Налог за пловидбеност ваздухоплова

НПВ 19-02-01

ПРЕДМЕТ: Замена склопа разводног зупчаника 4-цилиндричних магента типа *Slick 4200*, *4300* или *4700 (LASAR)*, произвођача *Champion Aerospace LLC*.

SUBJECT: Potential decreased service life of Slick 4-cylinder magneto distributor gear assemblies. **Based on process and component improvements following the initial release of this service bulletin, the serial number range is being extended in this revision. Magnetos previously returned for compliance to SB1-15 must be returned or inspected for compliance to this revision SB1-15A.**

Figure 5. K3008 Distributor Gear With Monel Electrode

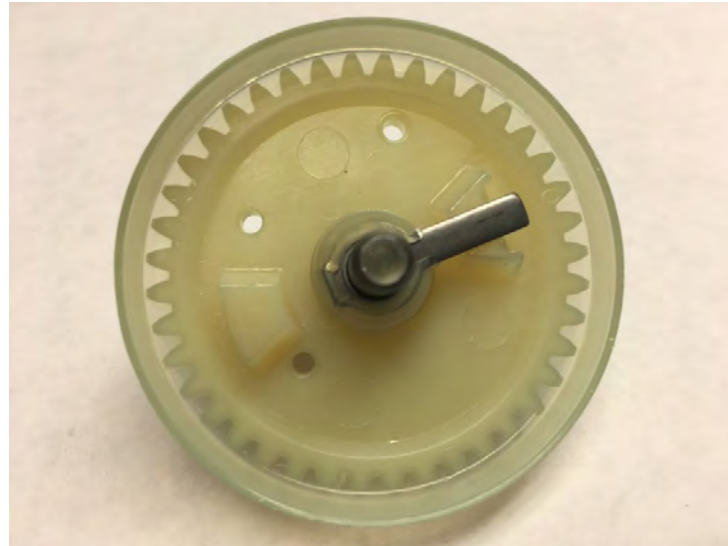
If it is not possible to confirm the version of the distributor gear that is installed in a given magneto from maintenance records, the magneto may be removed from the engine in order to have the housing and distributor block removed to allow visual inspection of the distributor gear. Distributor gears with Copper electrodes must be replaced with distributor gears with Monel electrodes.

While the subject magneto distributor gear assemblies met all acceptance criteria at the time of production, the previous Service Bulletin was issued in order to eliminate any affected 4-cylinder magneto distributor gear assemblies (see below: MAINTENANCE PARTS AFFECTED). Champion Aerospace improved the new replacement K3008 distributor gear assembly to address this issue. Champion Aerospace has made further improvements to the K3008 distributor gear assembly with the final change being the change from a Copper to a Monel distributor gear electrode as of August 2016, making the ultimate product more robust.

COMPLIANCE: REMOVE affected distributor gear assembly in subject magnetos and REPLACE with replacement distributor gear assembly, K3008, as soon as possible, not to exceed the next 50 hours. Document Service Bulletin compliance as written entry in applicable Aircraft and/or Engine logbook.

REMOVE K3008 distributor gear assembly in subject magnetos and REPLACE with replacement K3008 distributor gear assembly **as soon as possible**, not to exceed the next 50 hours.
